**TOWN OF HERNDON, VIRGINIA  
ARCHITECTURAL REVIEW BOARD  
WORK SESSION AGENDA  
SEPTEMBER 4, 2019  
HERNDON COUNCIL CHAMBERS BUILDING  
765 LYNN STREET  
7:30 P.M.**

**Case Number & Type:** ARB #19-33; New Construction  
**Case Summary:** Install new drive-thru clearance bar and order canopy on the commercial property for redesign of a fast food restaurant.  
**Case Location:** 1071 Elden Street, McDonald's

McDONALD'S SINGLE FACE MENU BOARD  
PROTOTYPICAL 115 MPH-INSTALL

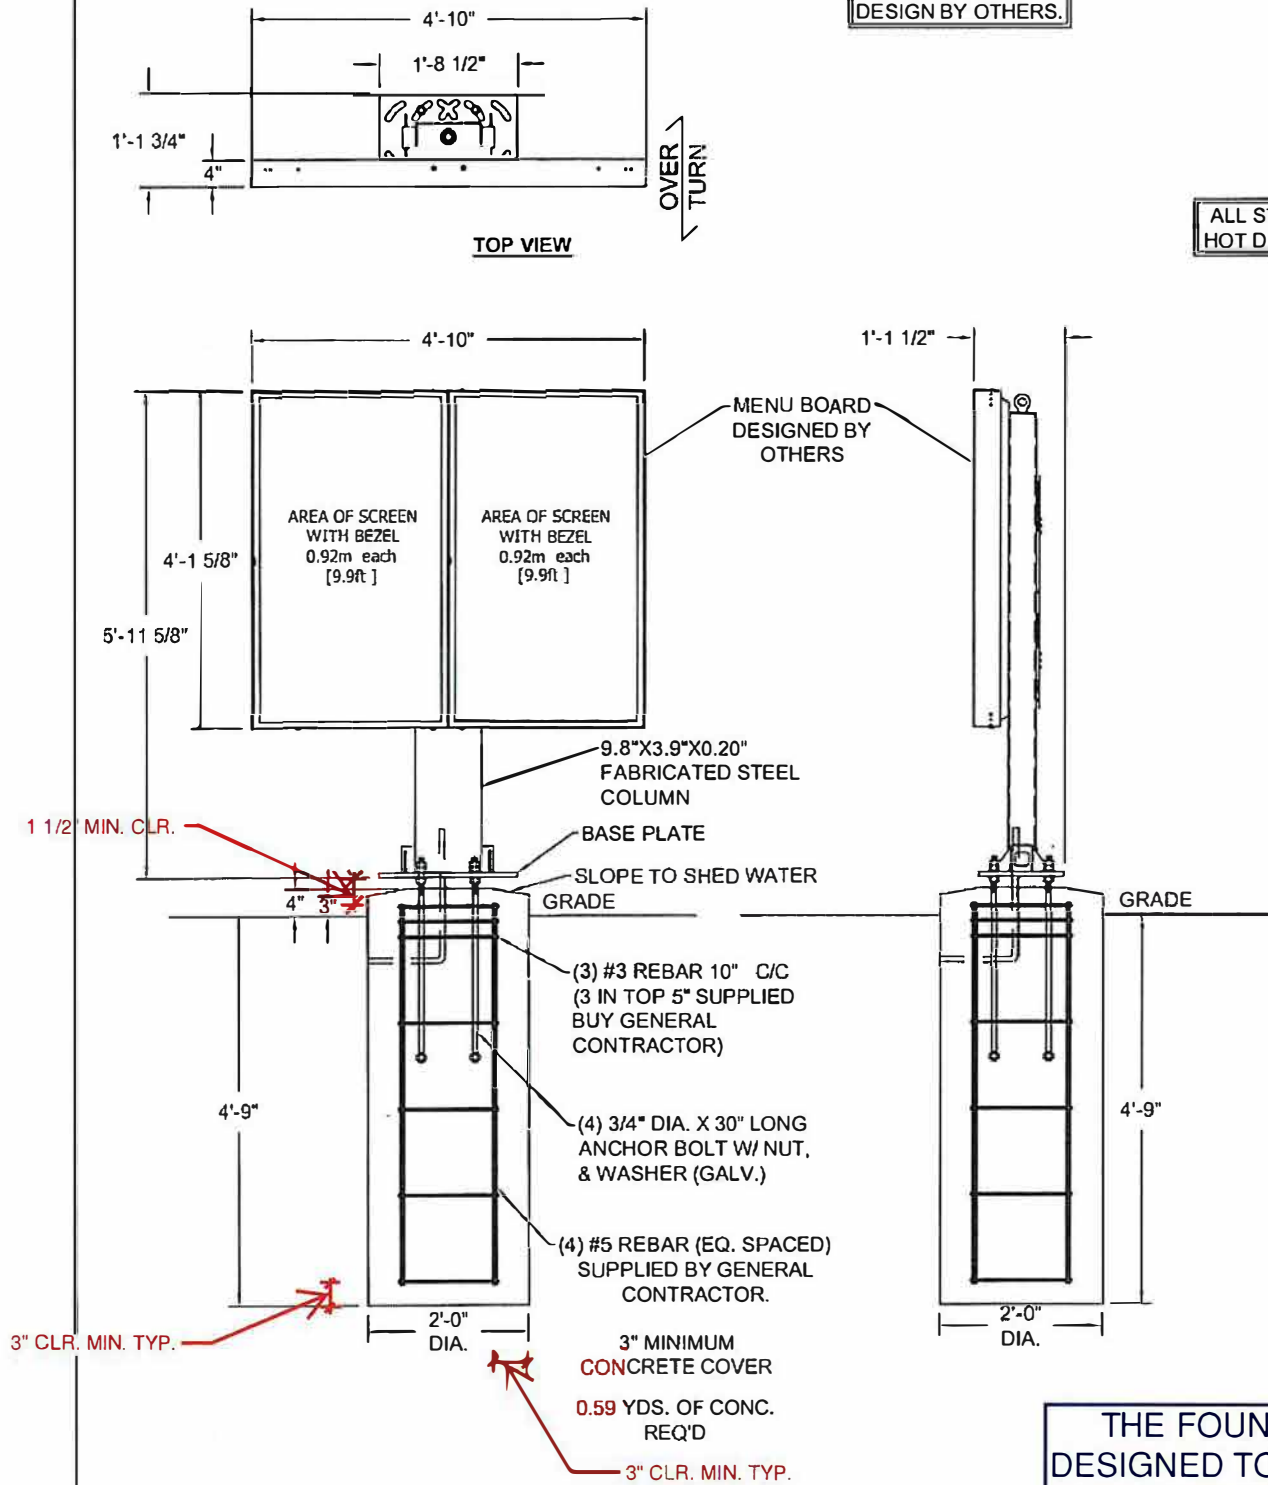
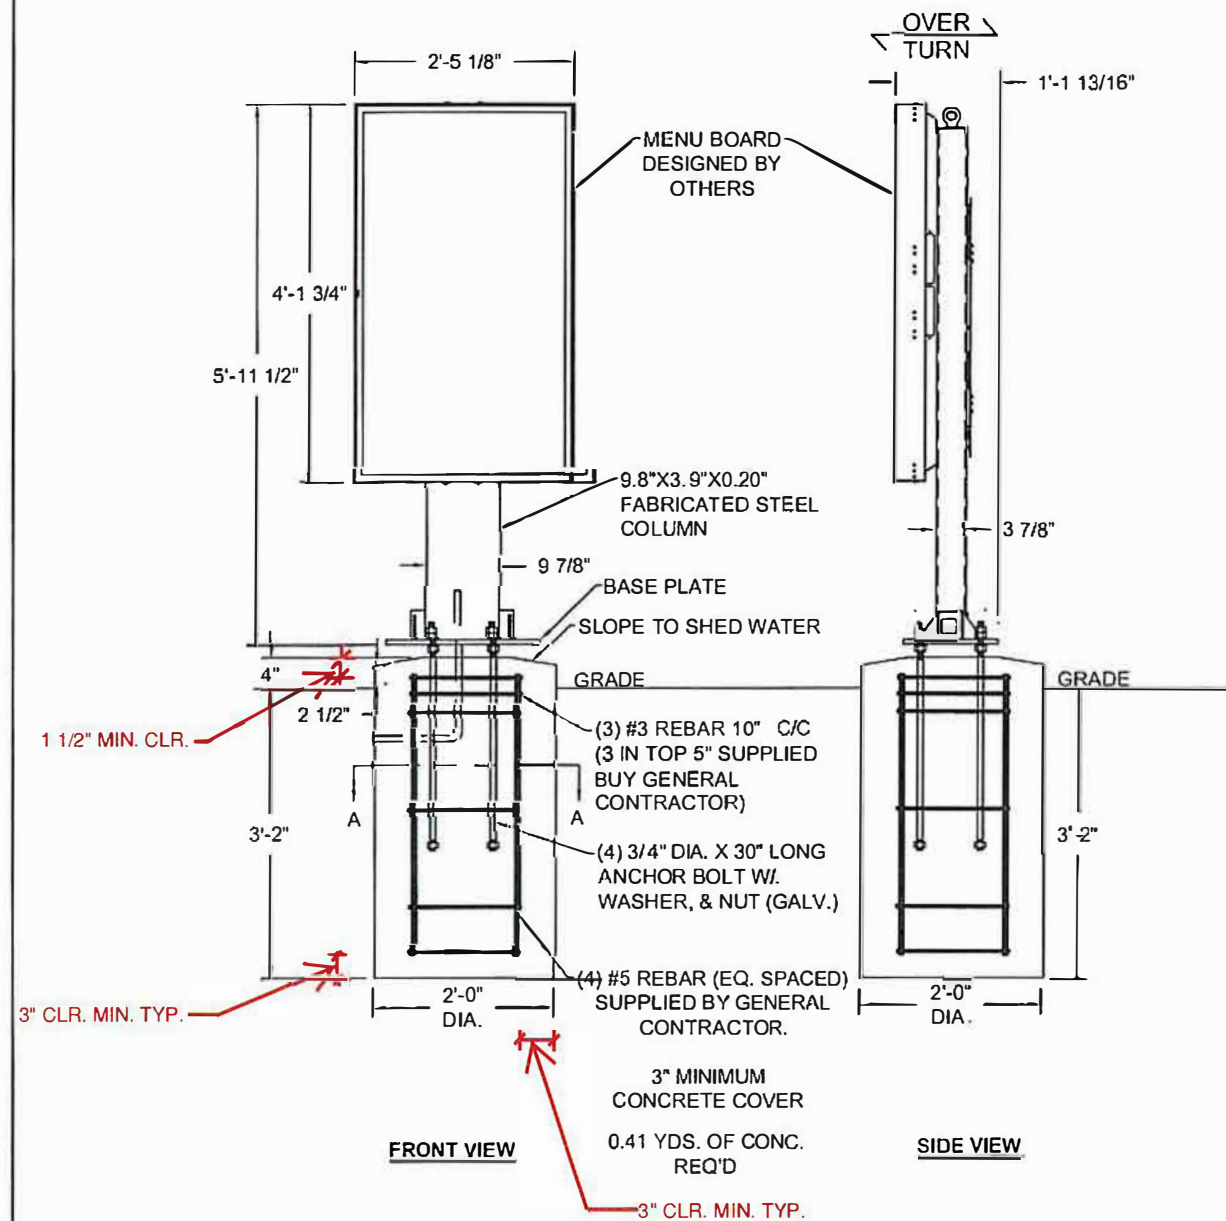
1. The application proposes a total of 30 square feet of freestanding signage to be distributed along the rear (east) elevation to provide menu information for the business' food service drive-thru operations. Section 78-141.4. - Sign standards for commercial districts, Table 141.4(a) specifies that one (1) freestanding sign per street frontage is authorized in the CS, Commercial Services, zoning district with one (1) square foot of sign area per linear foot of street frontage permitted and maximum of 50 square feet per sign. In this case, the property already retains one freestanding business identification sign along Elden Street, which complies with the referenced zoning ordinance section. In addition, there is a static-image, three-panel menu board that exists on site supporting the current drive-thru food service and is deemed to be legally non-conforming. The proposed signage does not meet the number, sign area, and overall sign dimensions of the referenced zoning ordinance section.

In this case, the non-conforming sign currently serving the business may remain or be replaced with one freestanding sign of equal or lesser sign area. Thus, the applicant may retain the existing identity freestanding sign along the street facing façade and may install one menu board sign to replace the existing menu board sign, but a third freestanding sign is not permitted. The Board may not act on this case until conformance to the zoning standards in the referenced zoning ordinance section is achieved in a revised sign design.

2. The proposed signs do not meet the Town Zoning Ordinance, Section, 78-140.6. - General standards for all signs regarding, the sign types, design, placement, and illumination. In this case freestanding signs may not be mounted on a single pole or post. Thus, a revised mounting design must be submitted to meet the referenced zoning ordinance section or be shown to mount the replacement panel on the existing non-conforming pole base. Staff recommends that the Board and the applicant consider using a proportional solid sign base made of the same materials and color as the proposed menu board enclosure, specifically the bronze aluminum, or use an exterior cladding material around a sign base that matches a material on the redesigned building facades.

3. The proposed signs do not meet the Town Zoning Ordinance, Section, 78-140.4. – Prohibited regarding the prohibition of any electronic sign that is generated by a series of moving images, such as an LED, digital display, or other video technology. Thus, a revised sign design must be submitted ensuring signage is limited to static images in order to meet the referenced zoning ordinance section.

4. The proposed signs generally comply with the applicable design criteria within the Town's Architectural Control District as specified in Section 58-96 of the Town Code of Ordinances (Attachment #4), but the inclusion of a digital display does not, if visible along a commercial corridor, not comply with the intent of the district . Staff finds that the proposed sign will clearly serve the purpose of providing information for patrons of the food service business and will be in keeping current proposed building design which is planned to successfully update and modernize the otherwise dated existing exterior design, if a legally nonconforming sign is either retained or replaced

If the applicant can revise the sign designs and resubmit design materials to staff no later than September 11, 2019, staff will have the opportunity to review and update its recommendations potentially enabling the Board to act on the case at the September 18, 2019 ARB Public Hearing. This potential for Board action presumes zoning compliance is achieved in the applicant's resubmission(s).

| <b>Recommended Motion:</b>  | Motion for continuance of ARB #19-35, in accordance with Alternative #4, to allow staff and the applicant to: <ol style="list-style-type: none"><li>1. Address the Town's Zoning Ordinance sign standards that do not permit the signs proposed in the application, and</li><li>2. Revise the ARB #19-35 application, as needed, and the staff recommendations upon resolution of the referenced zoning ordinance sign standards and the proposed freestanding sign(s).</li></ol> |
